SPECIAL USE PERMIT APPLICATION

Project Name: Merritt Mill Affordable Housing
Property Address: 800 Merritt Mill Road Zip Code: 27516
Use Groups (A, B, and/or C): A Existing Zoning District: R-3
Project Description: Construction of two apartment buildings with a clubhouse, parking and other site amenities. Approximately 35% the project area is in Chapel Hill with 65% in Carrboro.

Responses to Concept Plan Review Comments by Chapel Hill Community Design Commission
31 Aug 2017 (Revised 30 Jan 2018)

Thank you for reviewing the SUP application for the Merritt Mill Apartments and for working with staff to provide comments. This letter is written to provide responses to the TRT comments dated 12 Oct 2017. Below please find each of your comments followed by our responses in bold:

JOB NUMBER: 11603102
 DATE: 18 AUG 2017
 SCALE: AS NOTED
 DRAWN BY: DMC / DBB
 REVIEWED BY: CUR
SHEET
C1201

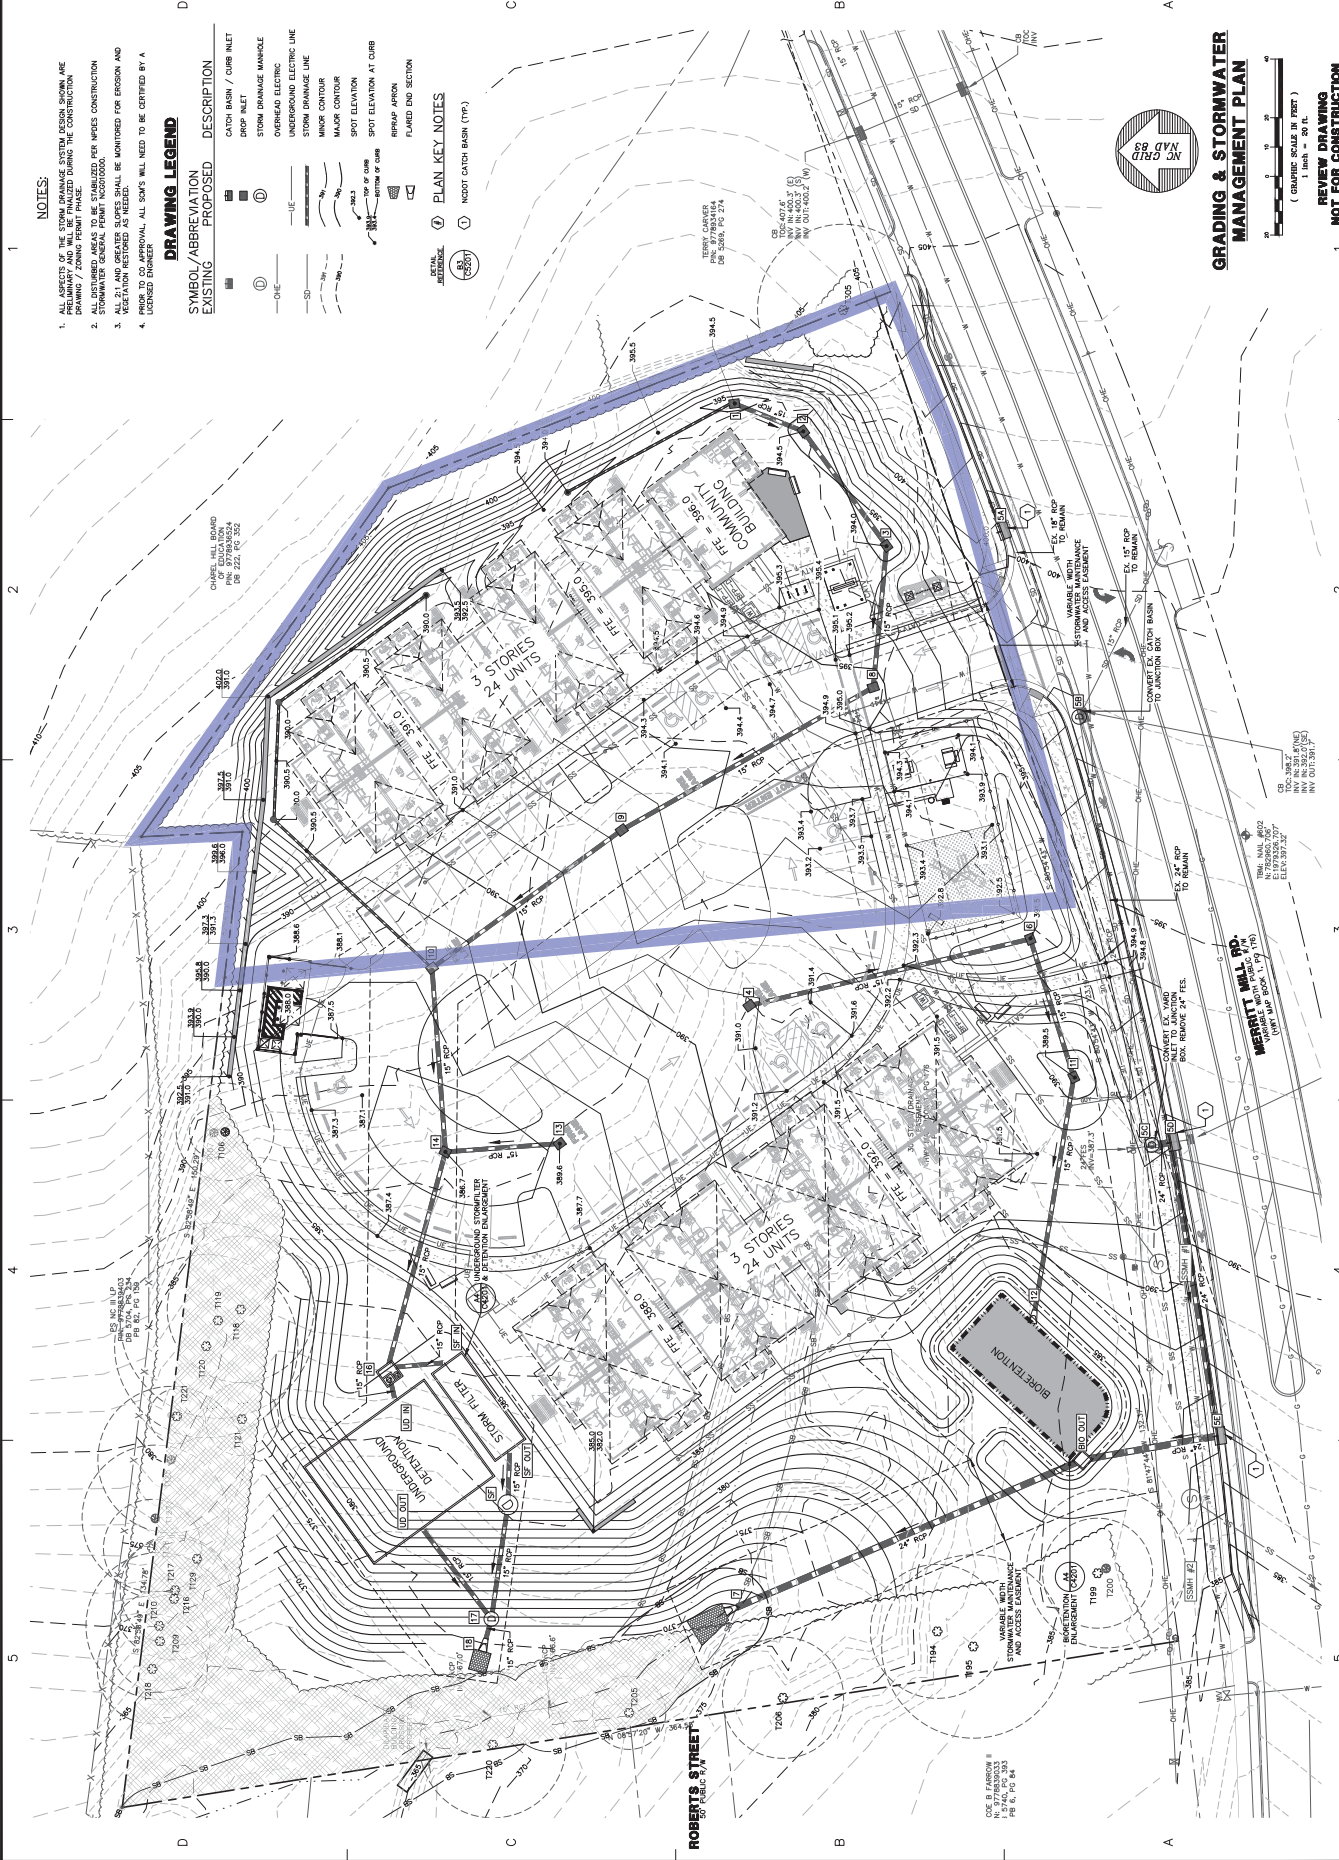
27. We recommend that the Demolition Plan and storm drainage plan note clearly all proposed changes in the Merritt Mill Road right-of-way.

30. On the Grading Plan, we recommend showing the tree protection fencing at the limits of disturbance and further suggest revising the grading (347 contour) proposed adjacent to the trunk of one of the two specimen trees to be protected on the site. Remove the tree symbol in the graded area west of the entrance; it does not appear to correspond to an existing surveyed tree. Indicate how proposed 2:1 slopes will be stabilized and maintained.

Additional notes have been added to sheets C0101, C1001, C1101 and C1201 for clarity on proposed changes within the Merritt Mill right-of-way. Construction drawing level detail will be provided with Final/ZCP Plans.

Plans have been revised to show tree protection fencing at limits of disturbance. The erroneous tree symbol noted above has been removed. For stabilization and maintenance of 2:1 slopes, see notes #2 and #3 on the Grading Plan. More specific notes (including a seeding schedule) will be provided with Final/ZCP plans.

ADA DUMPSTER PLAN
 (C5001) SCALE: 3/16\"/>

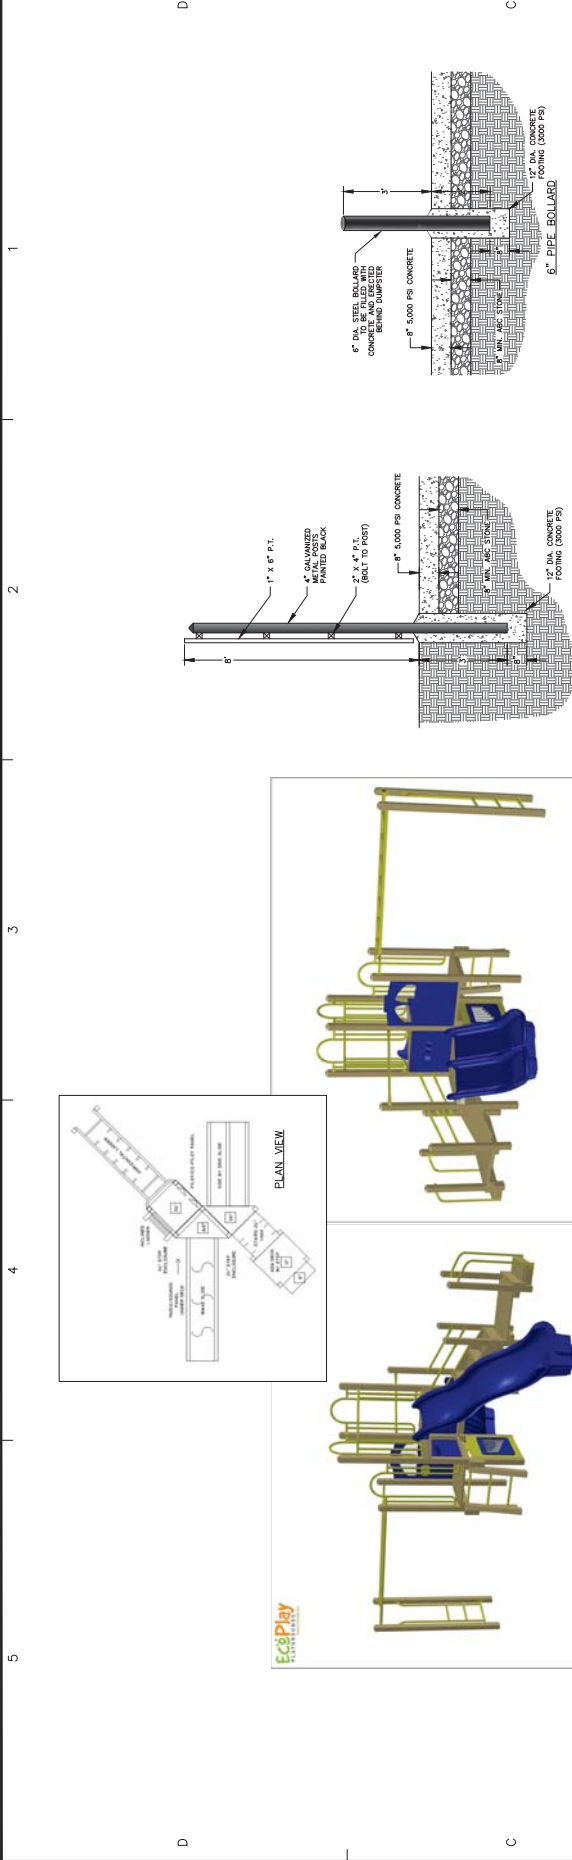
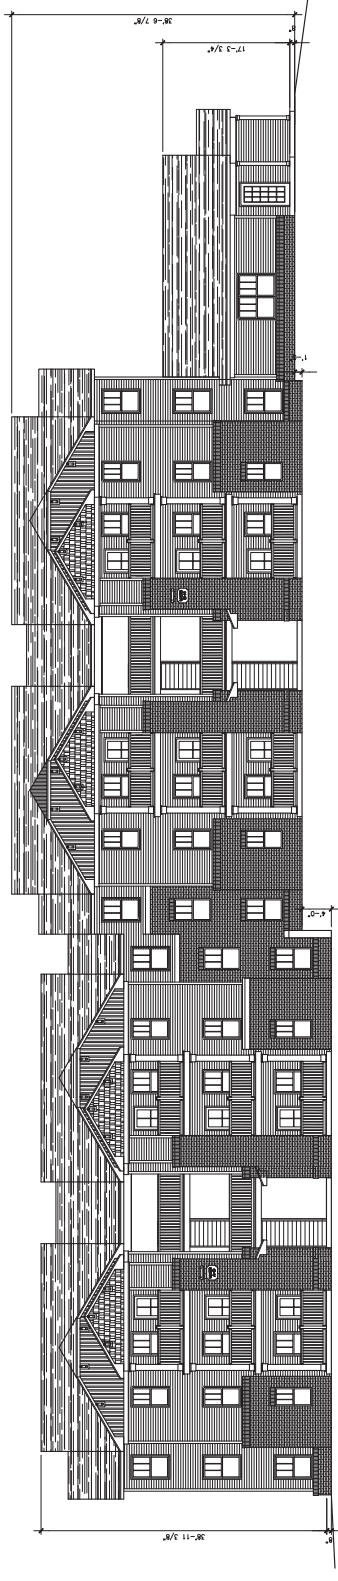
44. General Note - Add a detail of the Refuse/Recycling station that is dimensioned and at a scale of 1" = 10' or 1" = 20'.

1 West Elevation

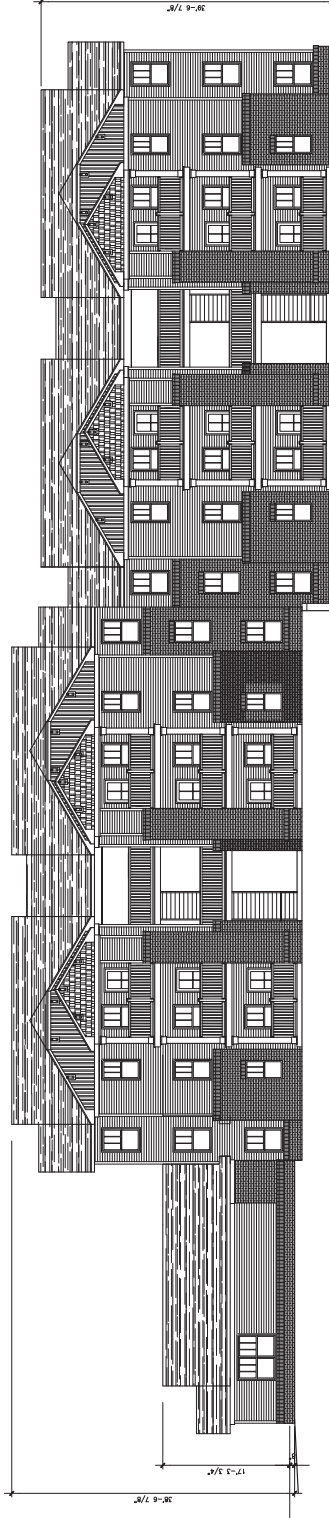
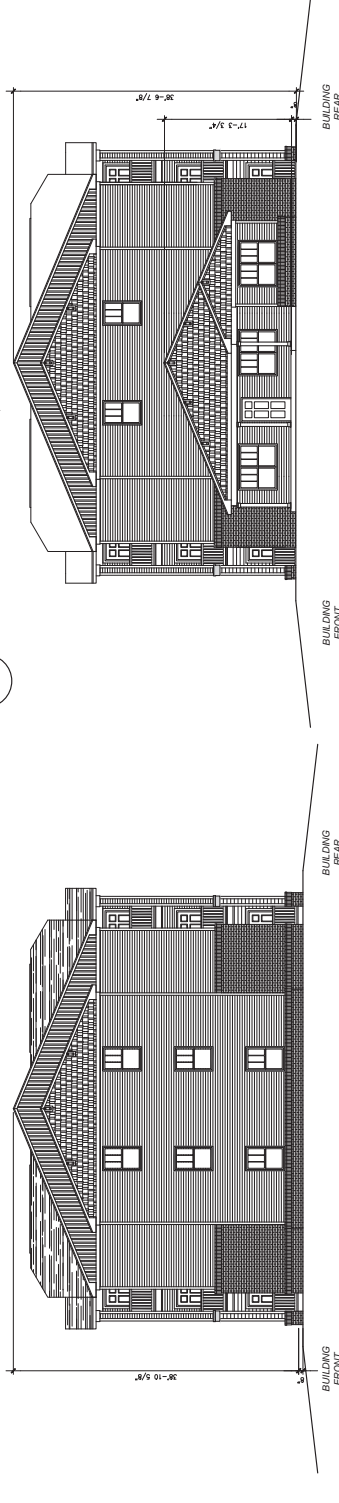
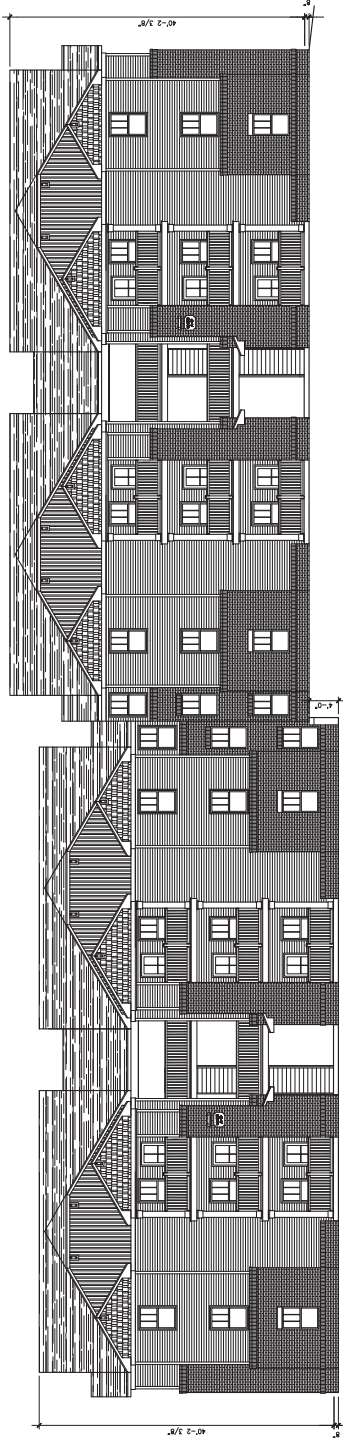
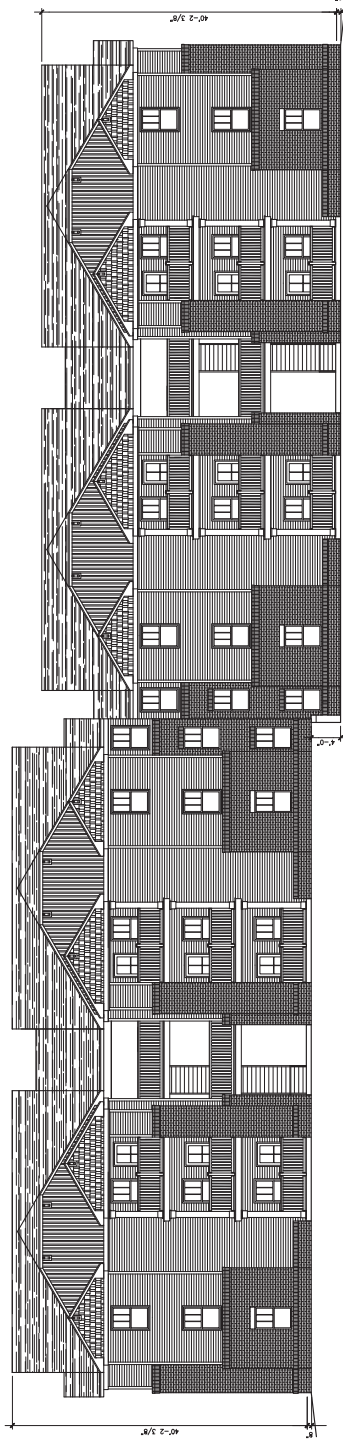
25. Elevations - Place dimension lines for height on all sides of the elevations and label according to direction rather than left, right, etc. Insert a key plan that shows which buildings are 1-bedroom and which are 2-bedroom.

Dimensions have been added to the elevations.
